ABBREVIATED PLAT AGENDA

September 3, 2025

**STAFF REVIEW AND RECOMMENDATIONS
PUBLIC HEARING
SEPTEMBER 3, 2025**

ABBREVIATED PLAT: RAVEN'S RIDGE 2025

TEST HOLE LOCATION EXHIBIT MAP

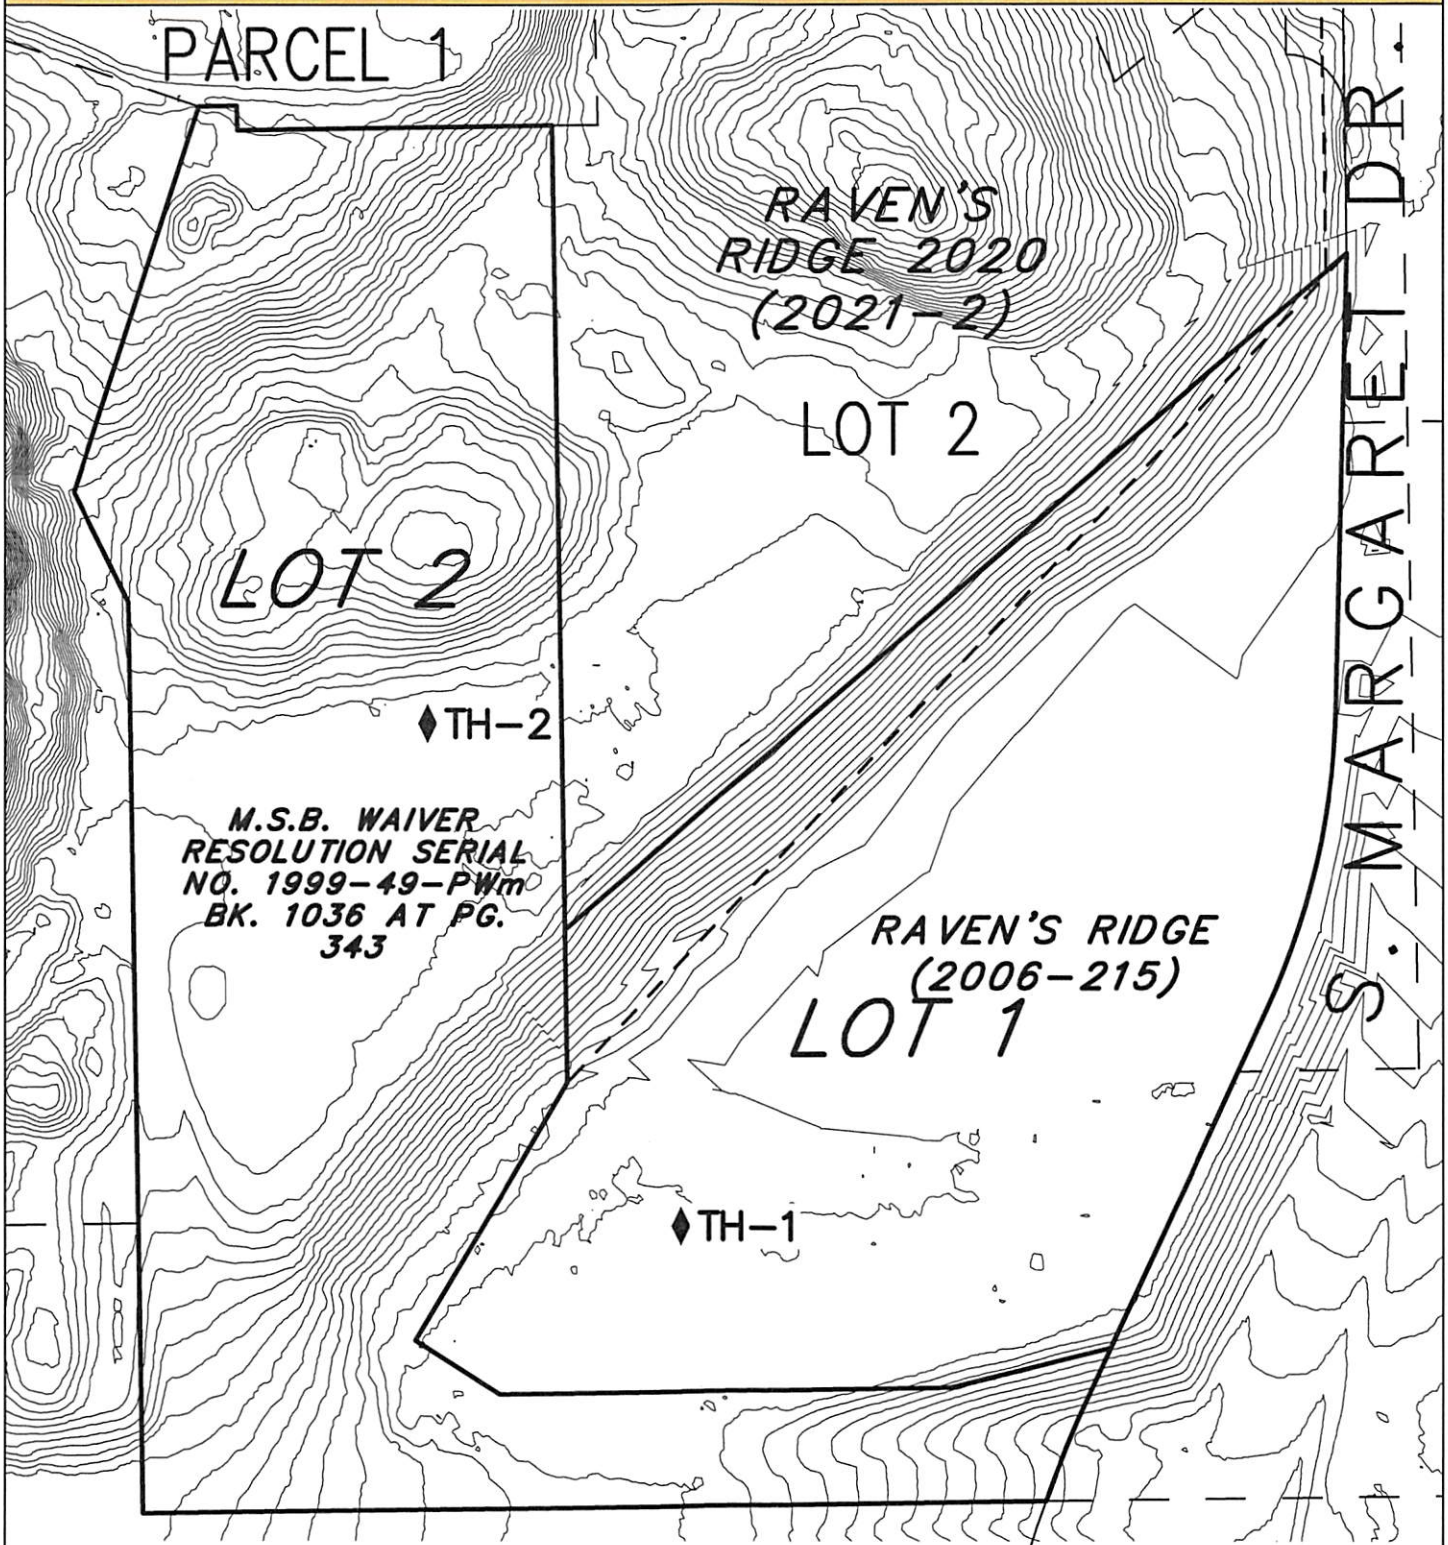
MSB DPW Pre-Design and Engineering Division (**Exhibit H**) notes that due to the elevation difference between the two lots, test hole 1 is not representative of the soils on lot 2. Additional information is required. *Platting staff notes that a revised soils report was received with an additional test hole to address Pre-Design and Engineering's concerns.*

Because of the topography and difference in elevation between the two lots, test hole 1 is not representative of the soils on lot 2. Please provide additional information.

I am afraid I won't have that updated report by Friday. We can't get the other test hole dug until next week. at which time I will get you the revised report.

EXHIBIT J

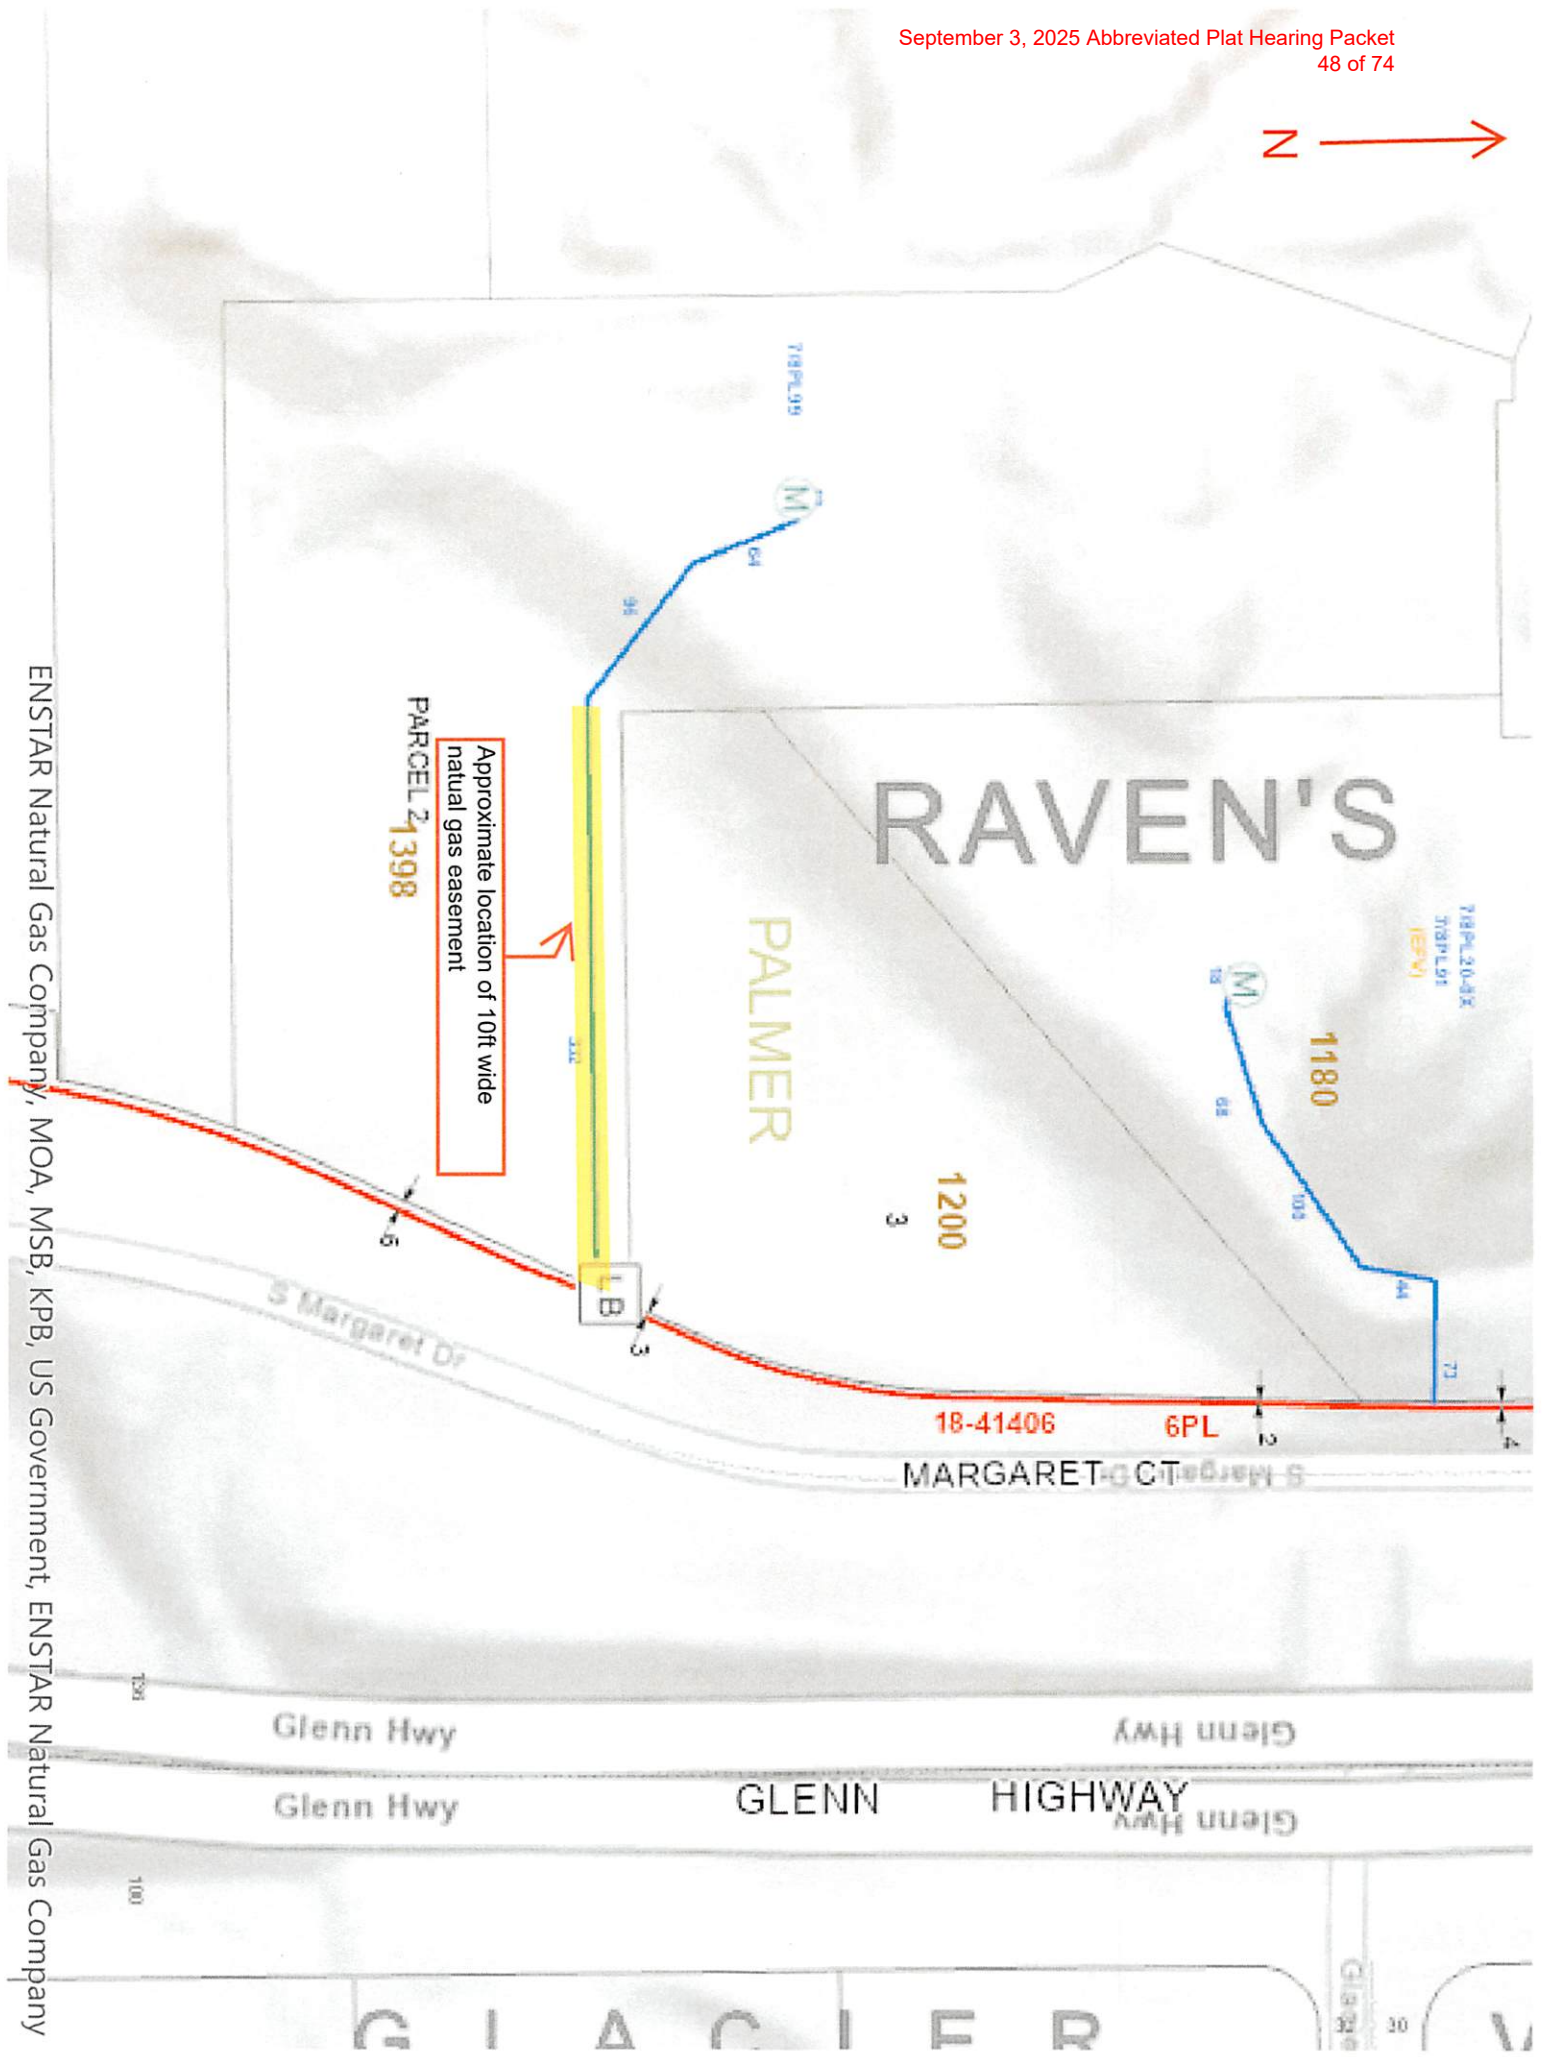
Utilities: (**Exhibit J**) ENSTAR notes the existence of a natural gas service line that appears to cross proposed Lot 1 to serve Proposed Lot 2. ENSTAR objects to the plat unless one of the following scenarios is met:

1. Add a note which says, "there is a ten foot (10 FT) wide natural gas easement centered on the existing service line." And draw in the location of the service line on the map and add, "Location of natural gas service pipeline and centerline of ten foot (10 FT) wide natural gas easement."
2. Owner signs an ENSTAR Natural Gas Easement document for a ten foot (10 FT) wide natural gas easement, centered on the service line at this location.

*Platting staff notes that this is an abbreviated plat and as such cannot grant easements. The petitioner will need to work with ENSTAR to grant the requested natural gas easement and show the recorded information on the final plat to be recorded. **Recommendation #4***
